To: T10 Technical Committee
From: Rob Elliott, Compaq Computer Corporation (Robert.Elliott@compaq.com)
Date: 16 April 2002
Subject: T10/02-134r0 SAM-2 SPC-3 SBC-2 SSC-2 Clearing effects of I_T nexus loss

Figure 1. Transport attention relationships

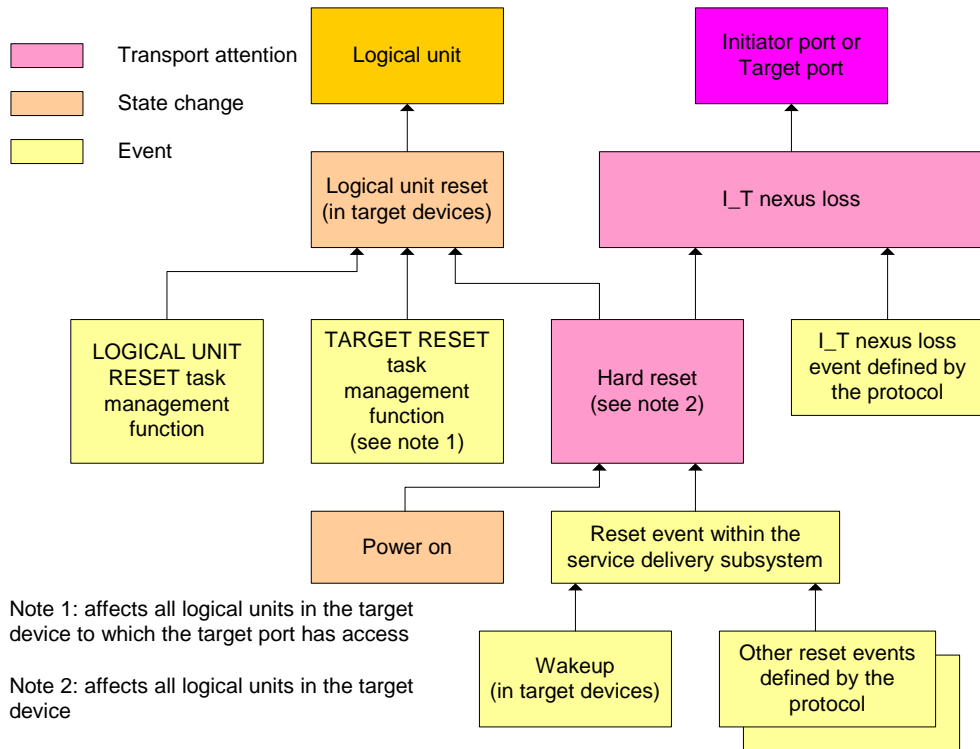
Figure 1 shows the relationships between I_T nexus loss, logical unit reset, hard reset, power on, and their associated events.

[Editor's note: need a better term than "state change" for the non-transport attention transport attentions.]
